RE: Permit Application #4-0103-16/16-0
Norlite Corporation
Part 373 minor permit modification
Cohoes (C), Albany County

This letter serves as a minor modification to the above-referenced permit. This modification shall be carried out in accordance with plans and specifications submitted on March 23, 2004 and modified by 4/6/03 letter and a 4/7/04 email. This project involves installing a pipe from the utility room to the trench in the Low Grade Fuel storage building and modifying the secondary containment in this building by allowing material pumped through this pipe to enter the secondary containment catchment area.

Re: Utility Room Sump Project

NORLITE CORPORATION - COHOES, NY
UTILITY BUILDING
VACUUM PUMP ROOM
SUMP INSTALLATION

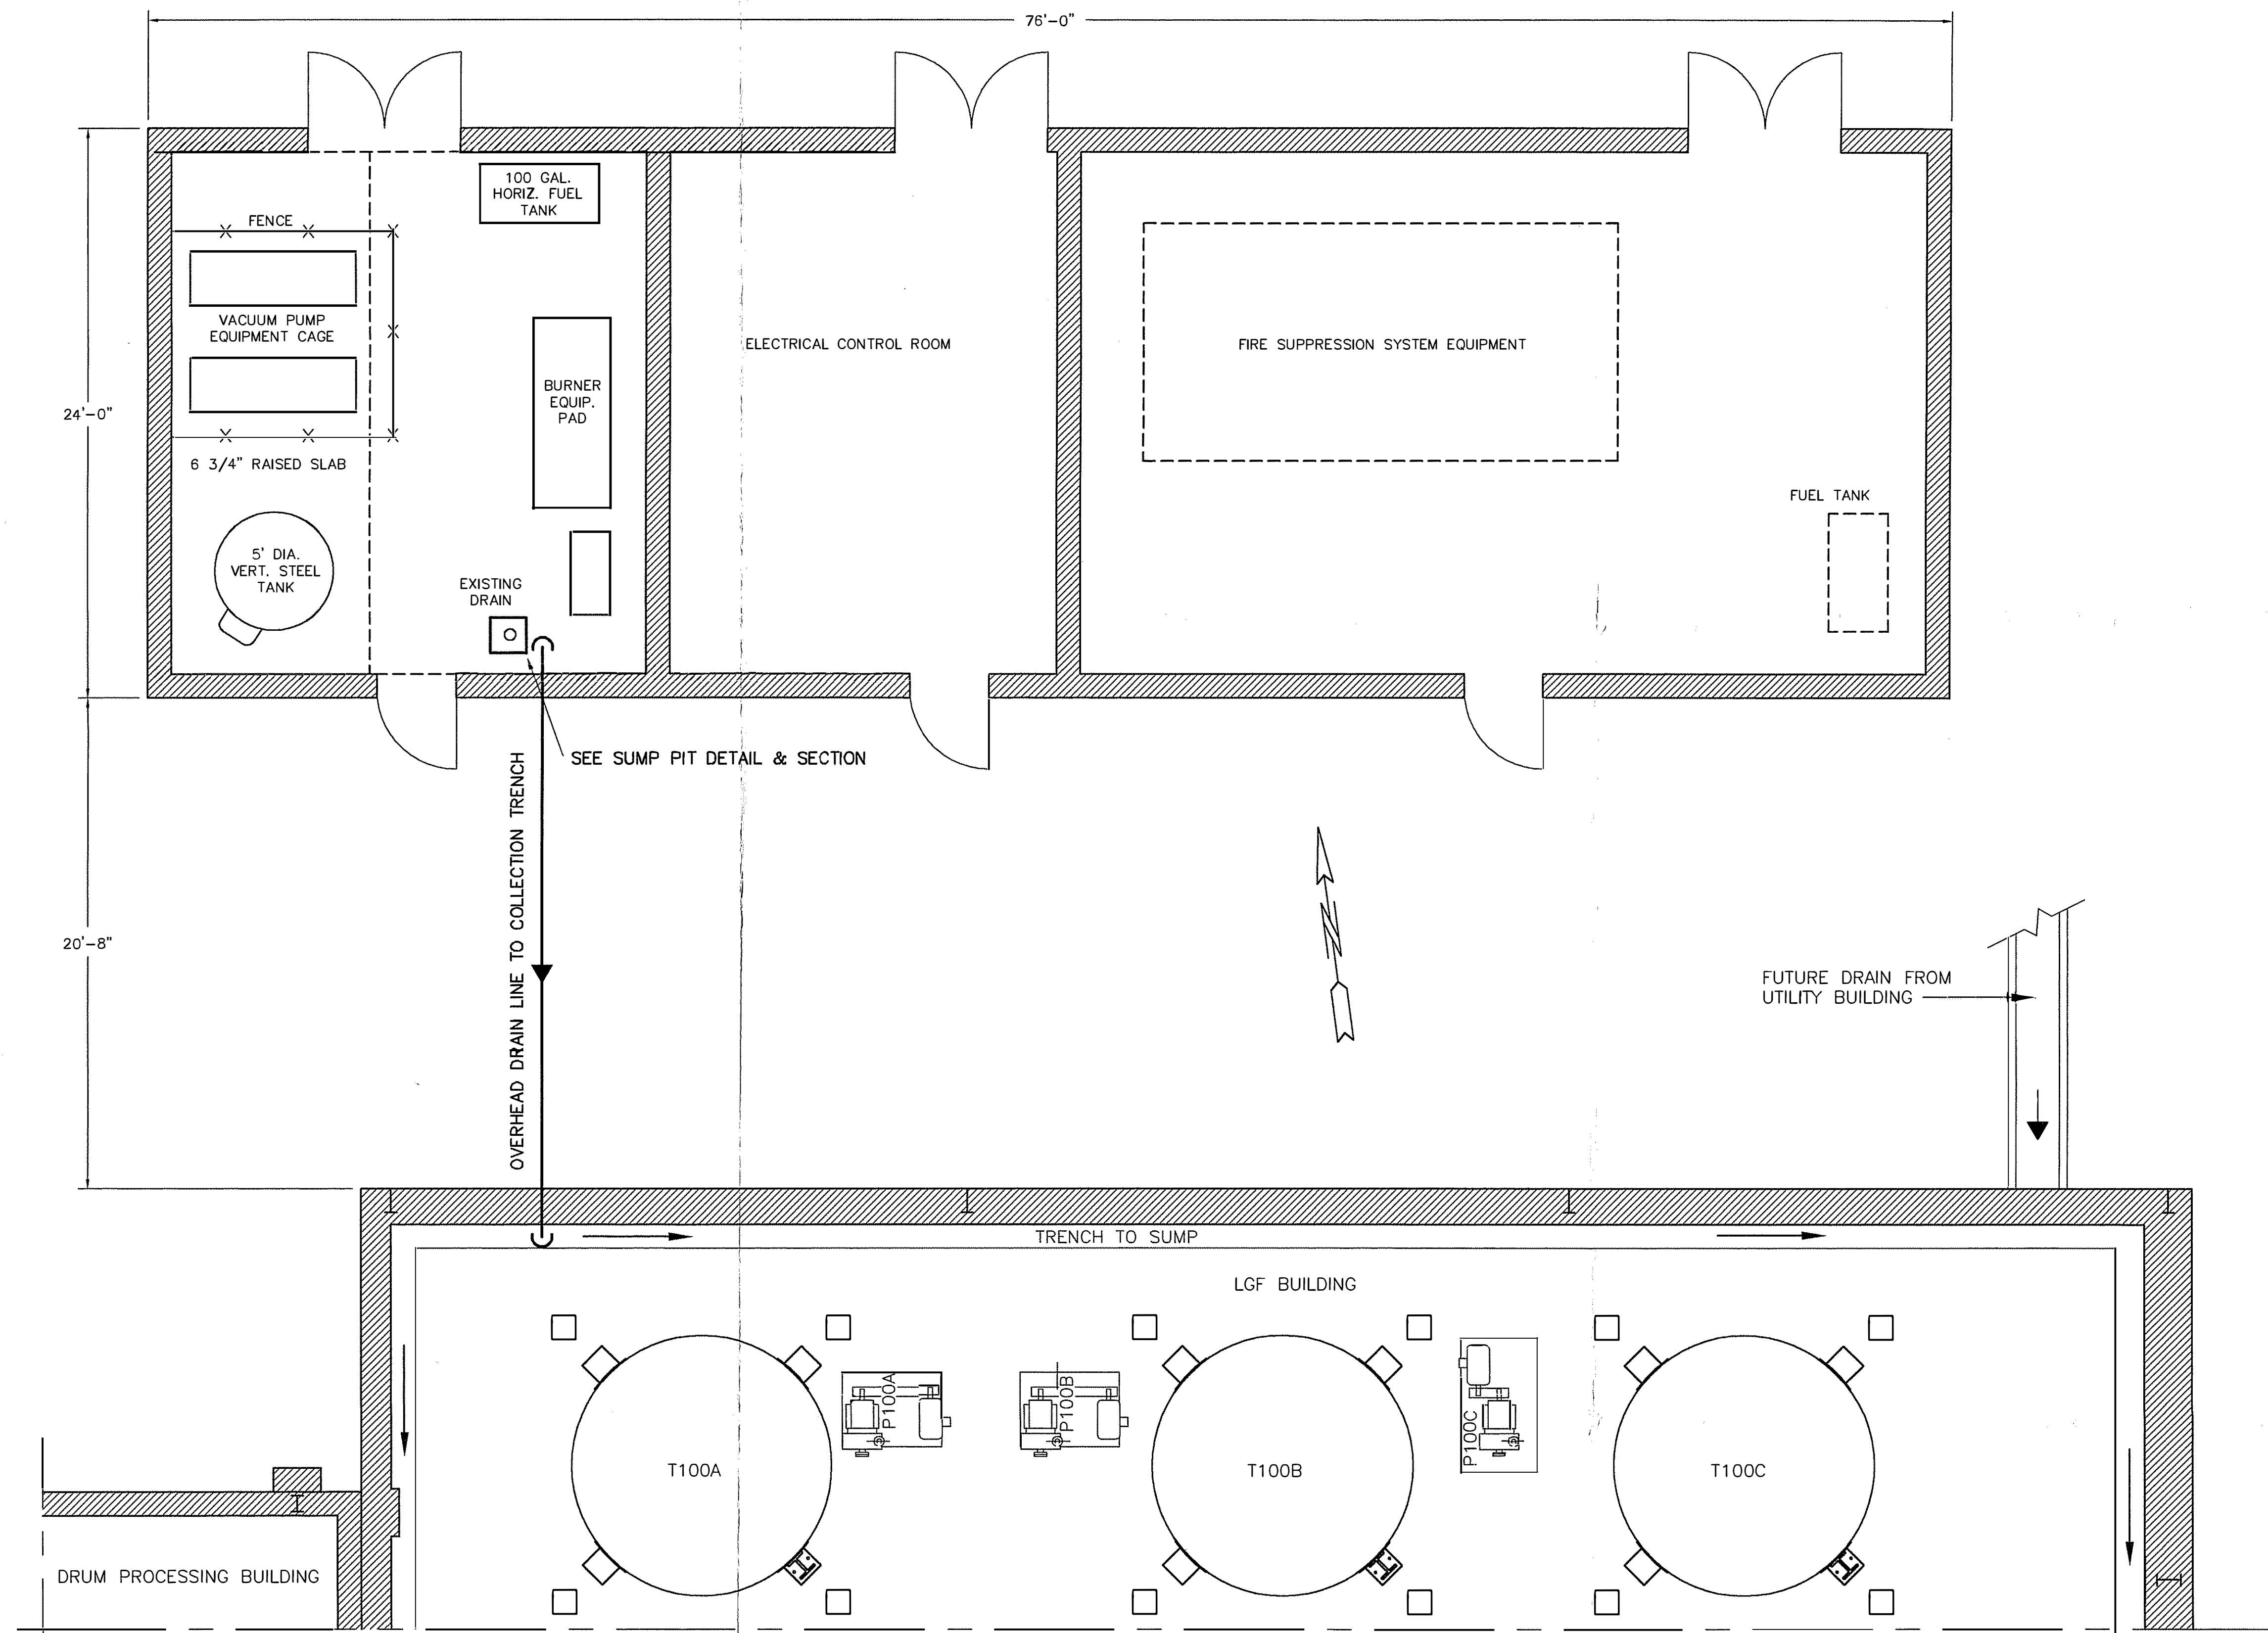
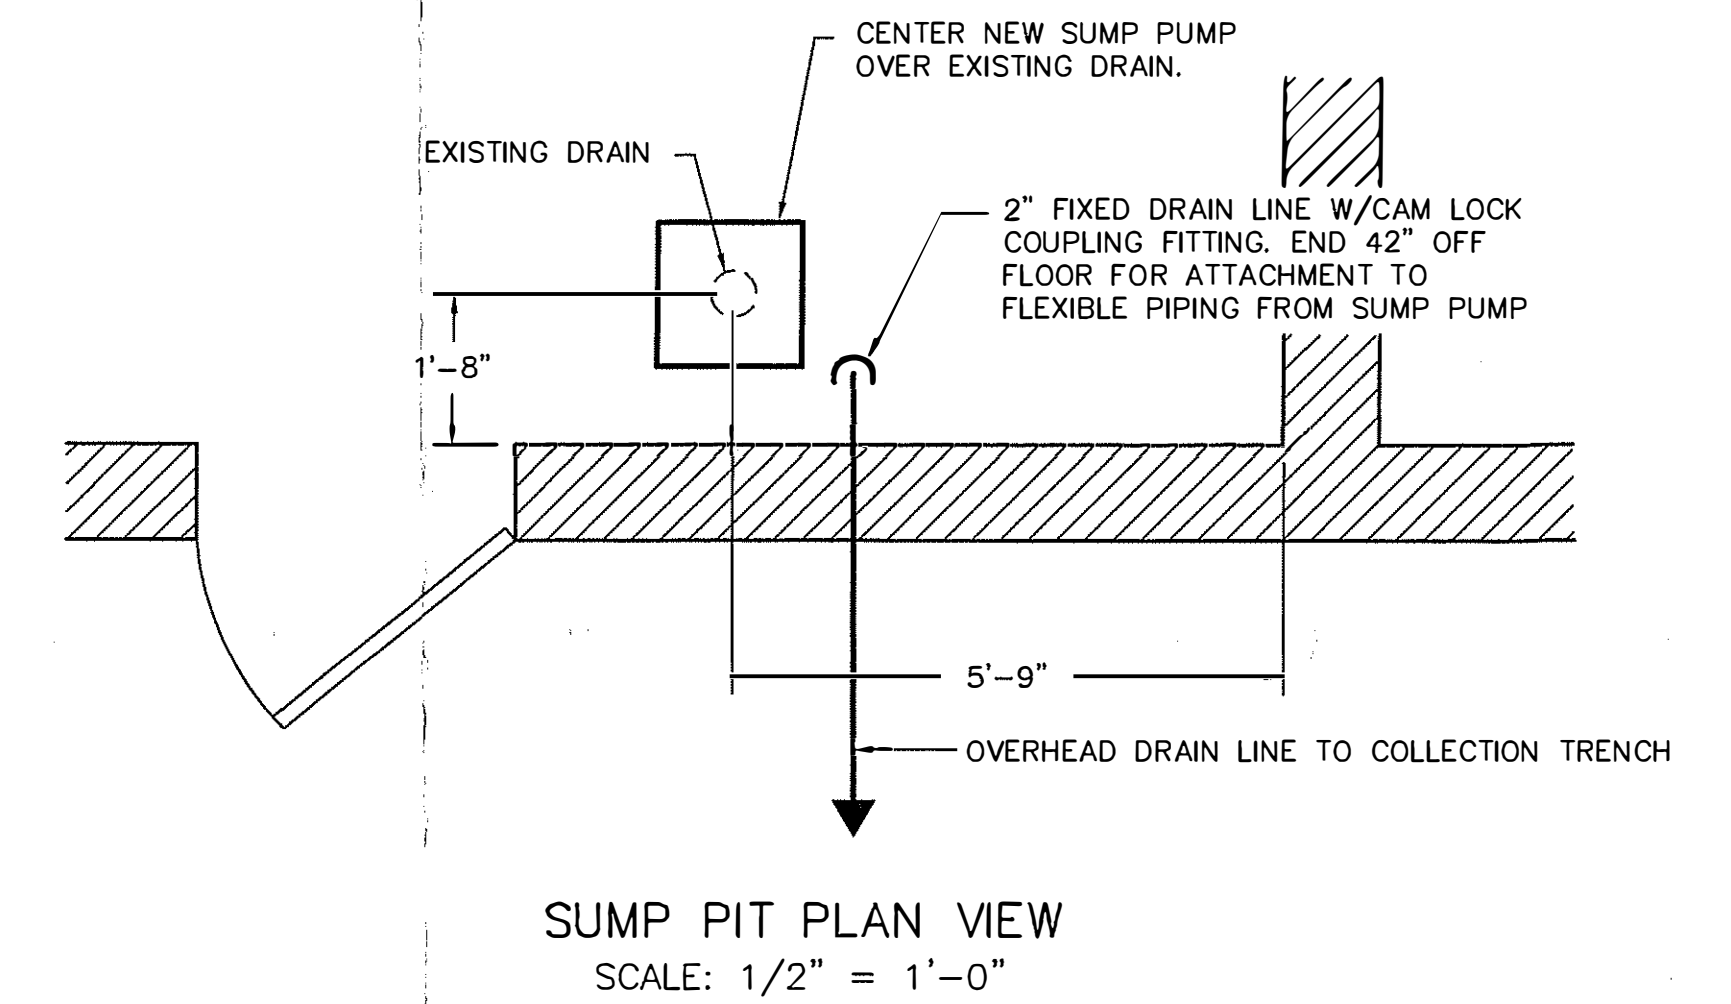
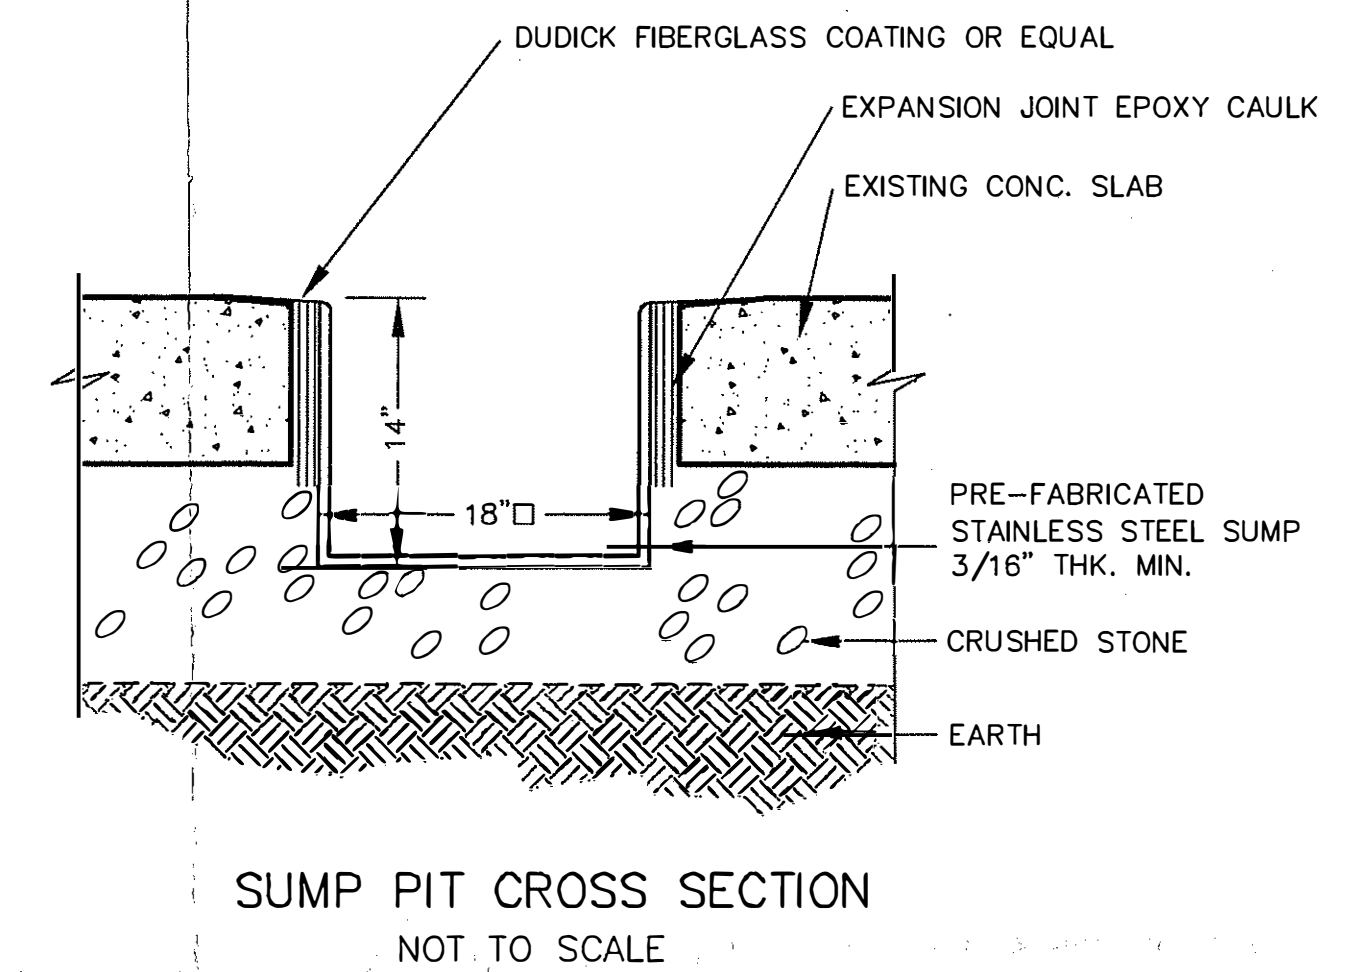
There was also concern of how the piping will be located in the LGF Building. After the pipe from the utility room comes through the side of the LGF Building, above the concrete containment, the pipe will have a 90° elbow that will direct it to the trench of the LGF Building. There will be piping installed all the way from the 90° elbow directly into the floor trench.

The project will involve liquid being pumped from the sump that will be constructed in the LGF Utility Room to the LGF building trench. As shown in the drawing, the piping will be aboveground and will enter the LGF building above the concrete wall, therefore avoiding a breach of the concrete containment structure. Norlite is prepared to implement the project upon approval by the NYSDEC.

This letter serves as a minor modification to the above-referenced permit. This modification submitted on March 23, 2004 and modified by 4/6/03 letter and a 4/7/04 email involves installing a pipe from the utility room to the trench in the Low Grade Fuel storage building and modifying the secondary containment in this building by allowing material pump through this pipe to enter the secondary containment.
